ADDENDUM NO: 3

PROJECT: Hamilton Heights High School Phase 2 Projects

PROJECT NO: 2023060

DATE: 03/05/2024

EXTERIOR WALL MOCK UP

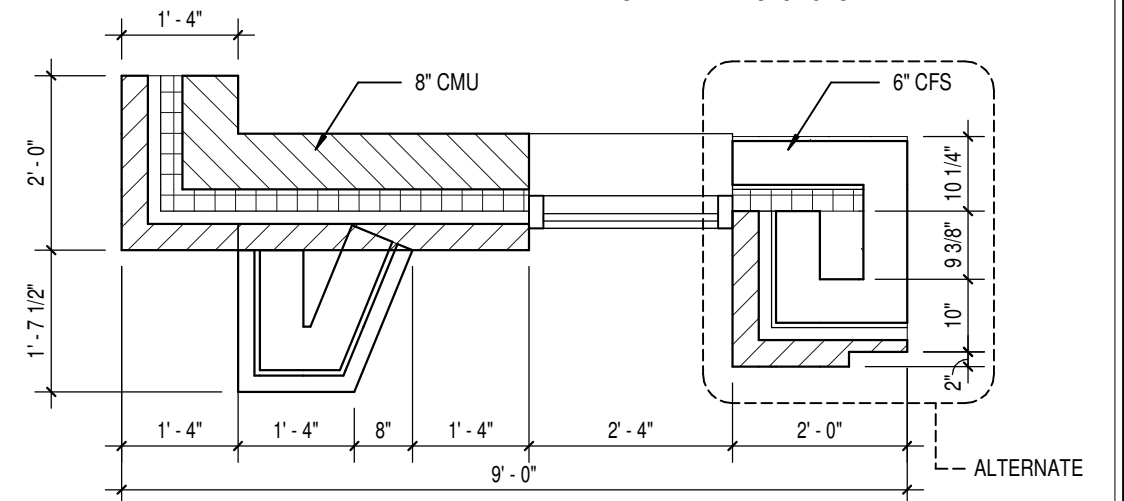
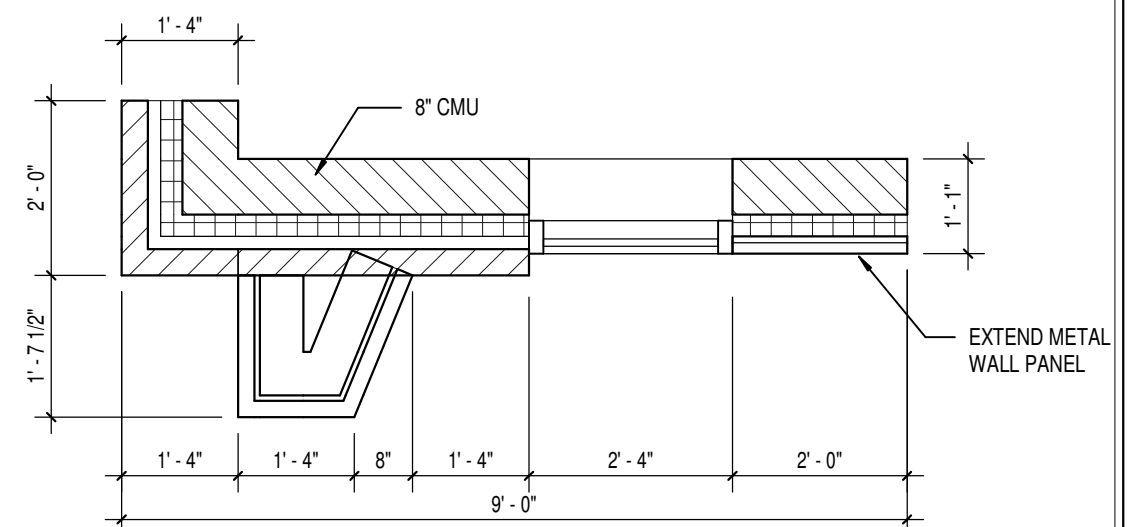
- A. ADD sketch of exterior wall mock-up

L101

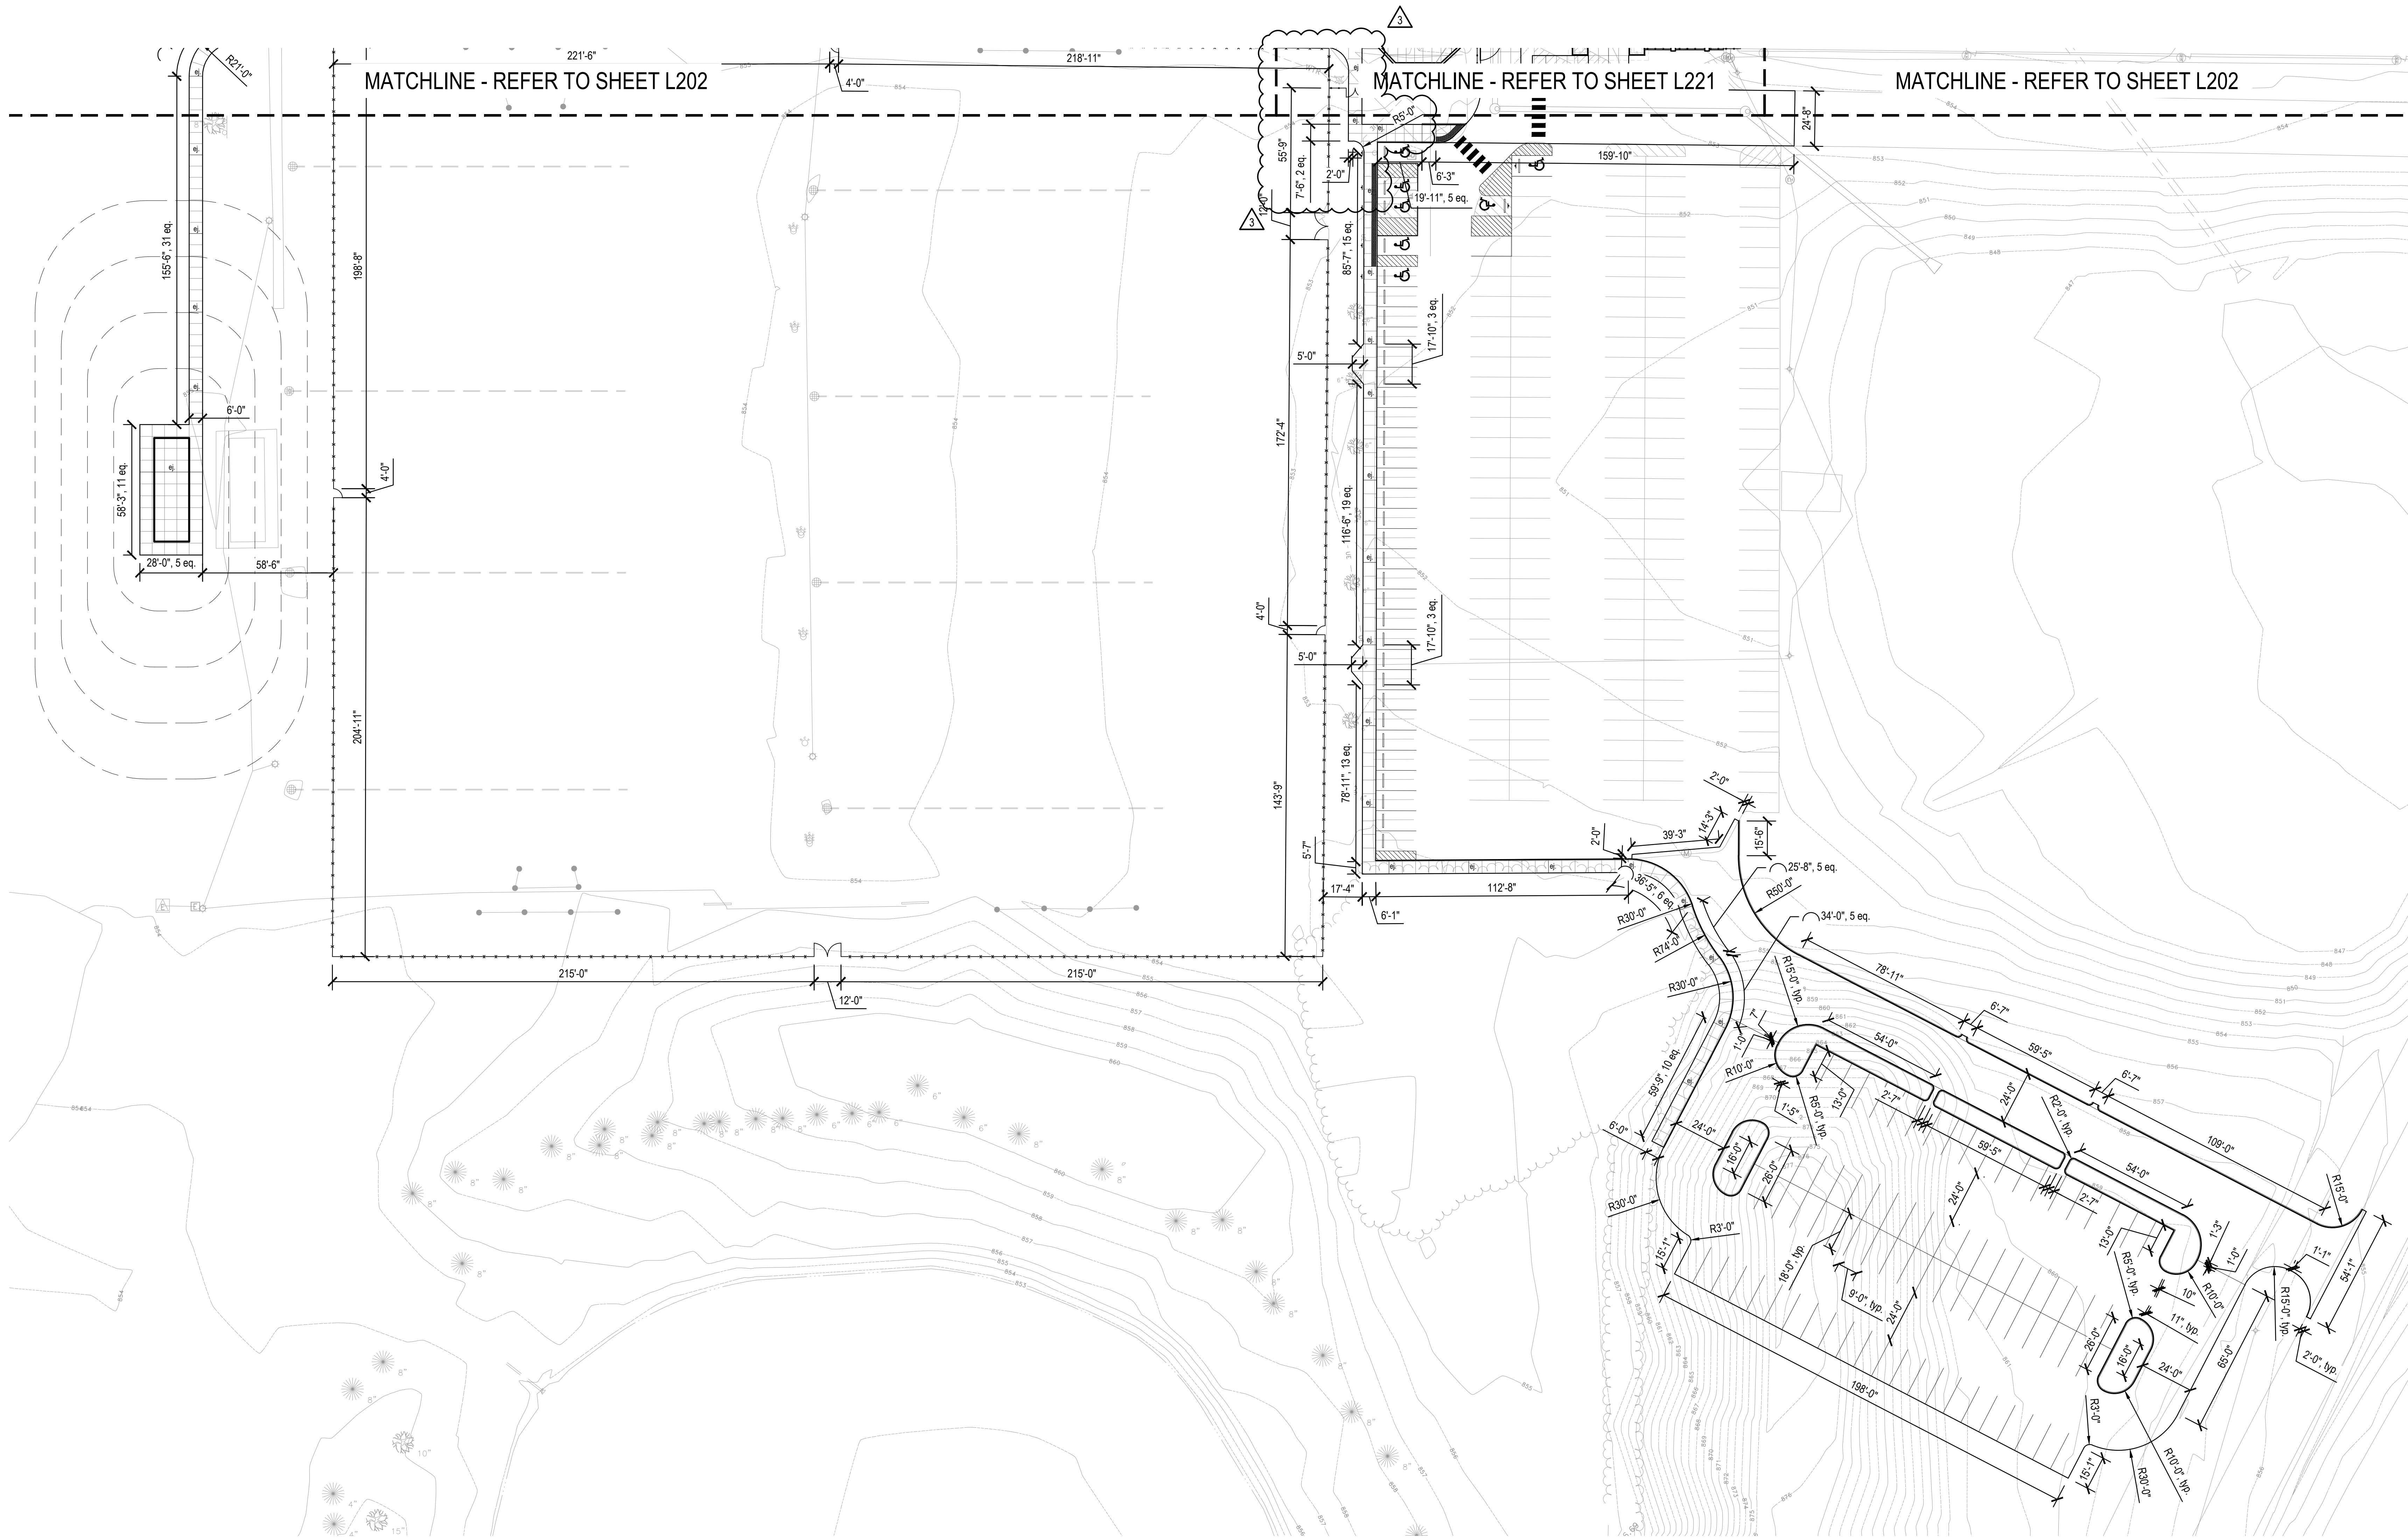
3.4 L101 – SITE MATERIALS PLAN

- A. Modified the sidewalk at the northwest edge of the north parking lot

L201

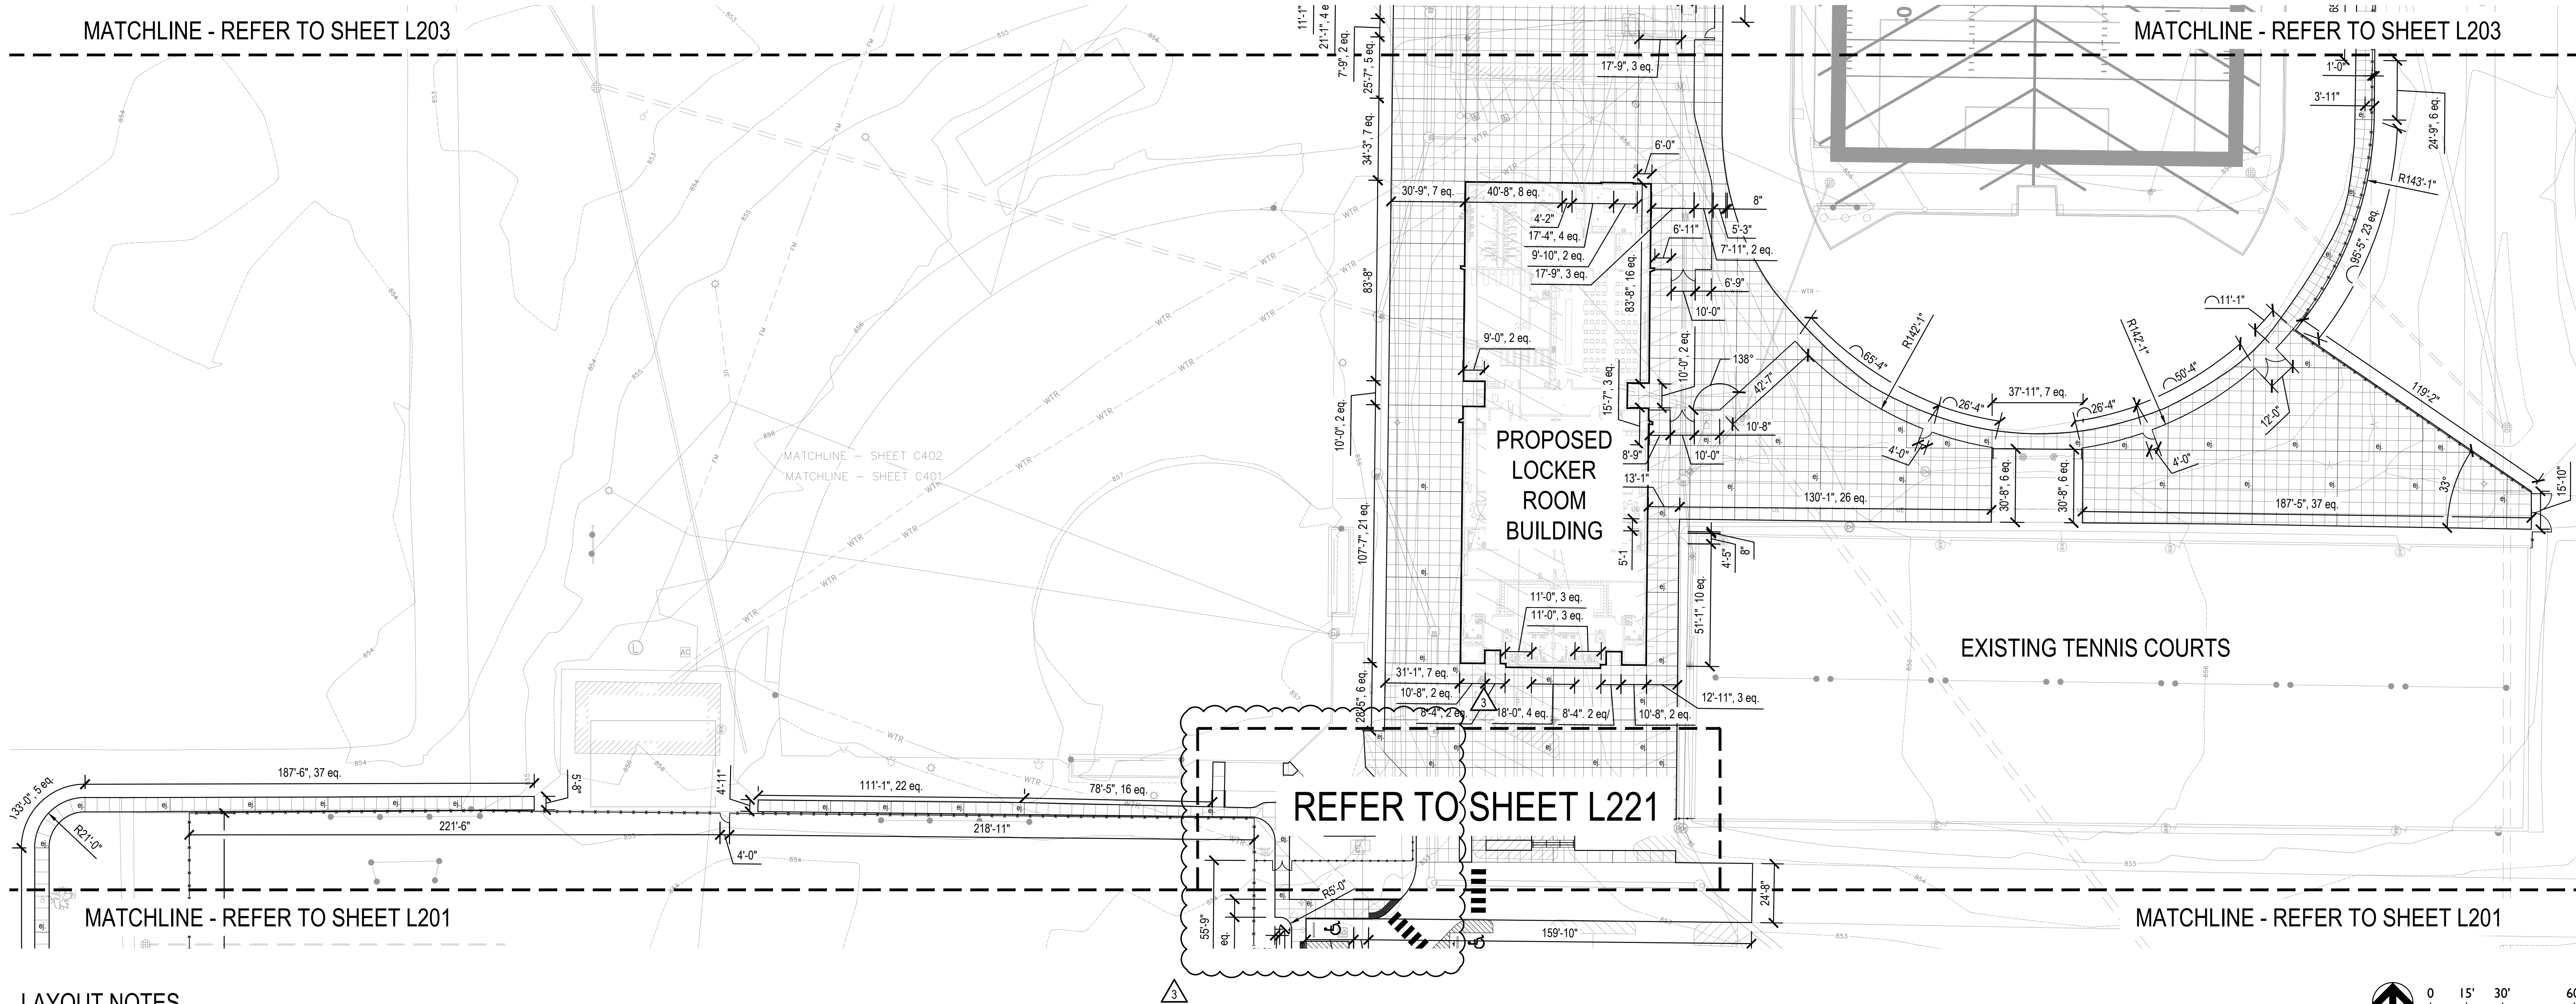
3.6 L201 – LAYOUT PLAN

- A. Added Dimensions to the Modified sidewalk at the northwest edge of the north parking lot.

LAYOUT
PLAN
ENLARGEMENT

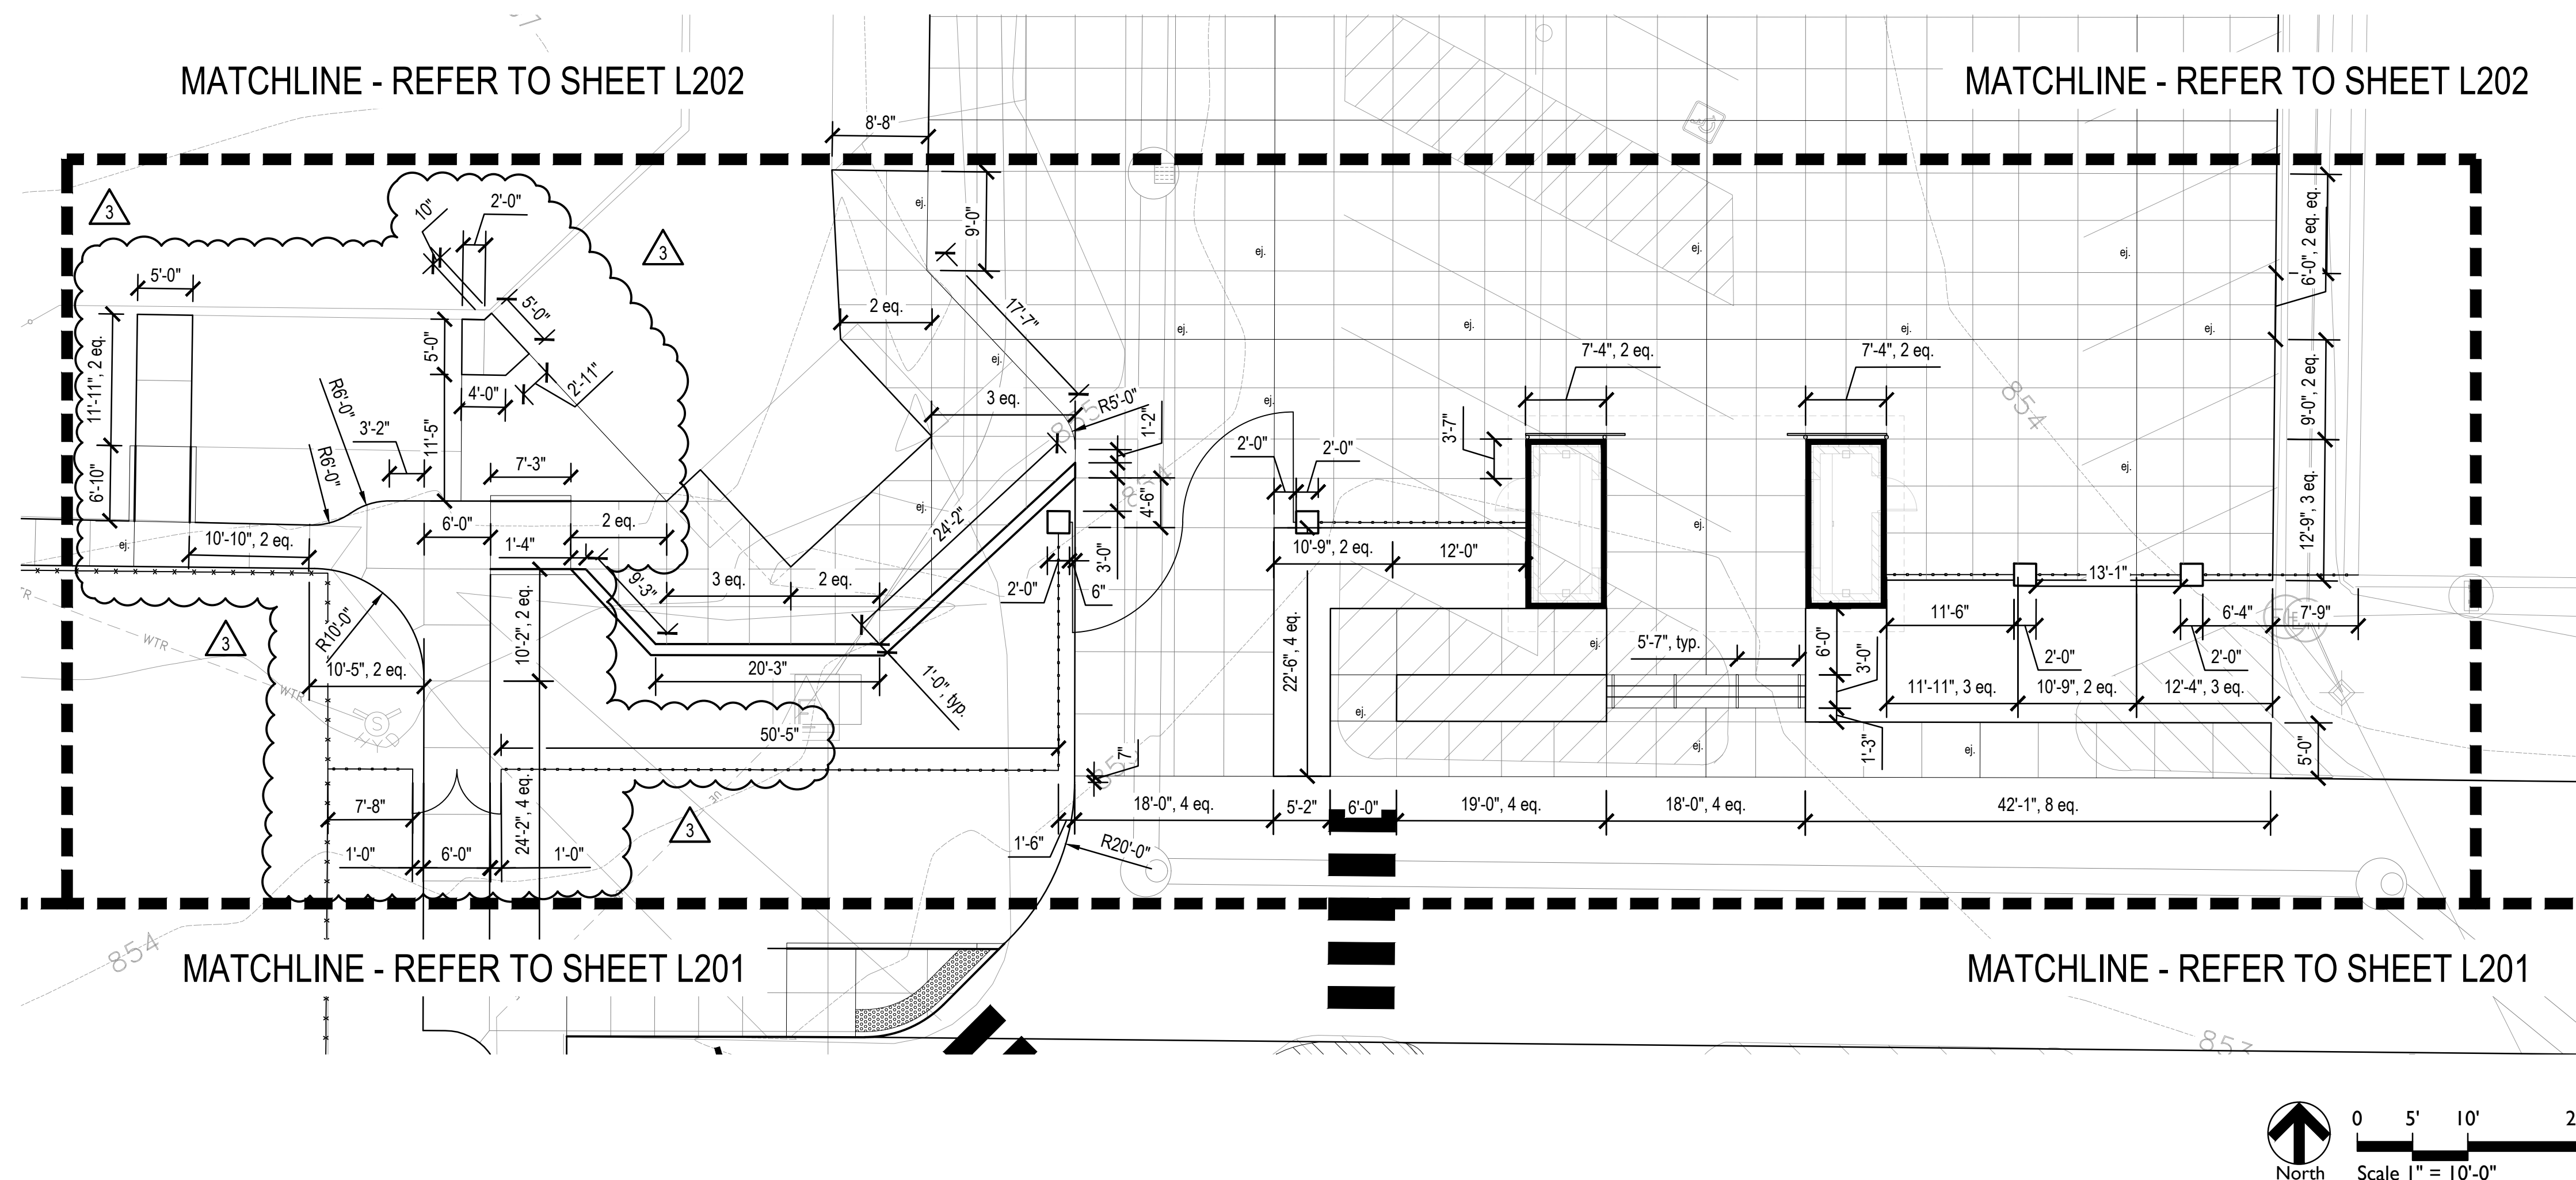
3.8 L222 – LAYOUT PLAN ENLARGEMENT

- A. Added Dimensions to the modifications made on L102.
